**WESTBROOK PLANNING BOARD
TUESDAY, JANUARY 5, 2021
MINUTES**

3. **2020.26 – Subdivision – Greenfield Place – Bramblewood, LLC: The applicant is proposing a 3-lot and 28-unit condominium development on a private driveway located on New Gorham Road. Tax Map: 027 Lots: 184 and 184C Zone: Residential Growth Area 1 Use: Dwelling, Single-Family, Dwelling, Two-Family – Public Hearing**

Map Legend

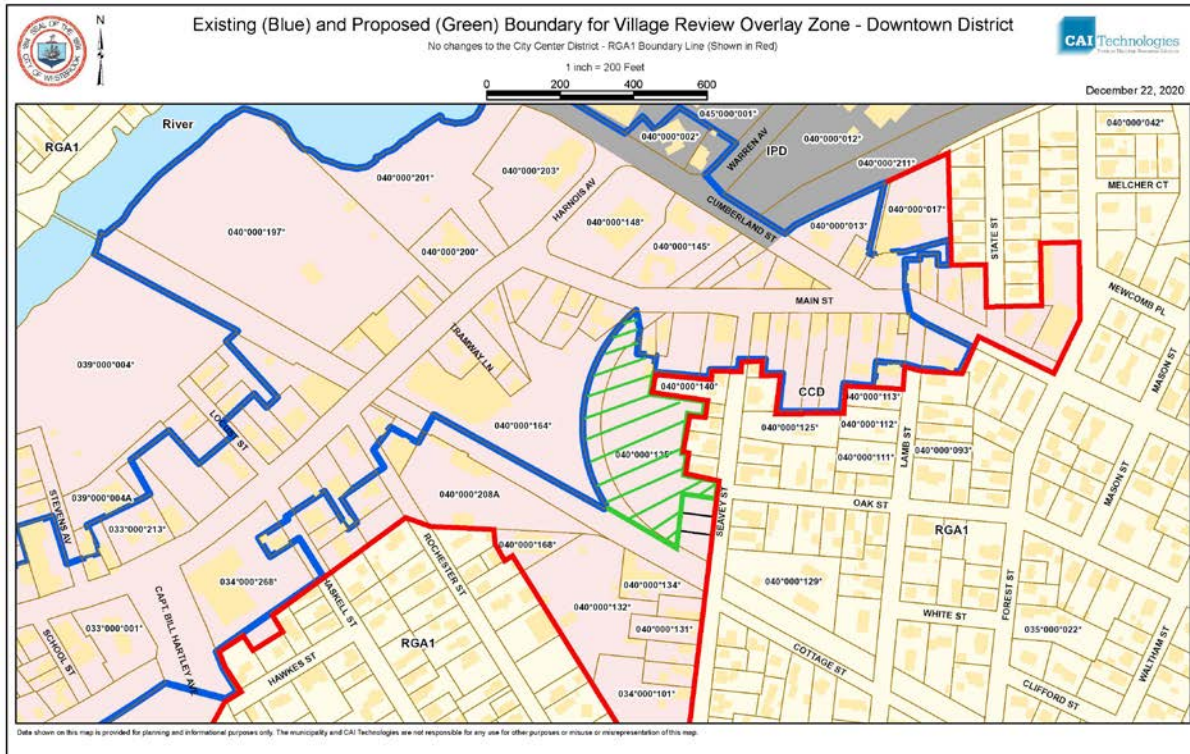
Robin Tannenbaum I am in general support of this proposed Zone change. I agree with the gentleman from Stockhouse Station with everything he said. I know we are not in the Site Plan review yet, but I think we need to acknowledge that we may allow something that is marketable different than everything else on this side of it. It is a big change.

I was surprised when I saw this and drove around a couple of times that it is considered to have frontage on Main Street. I am unable to tell this from the diagram.
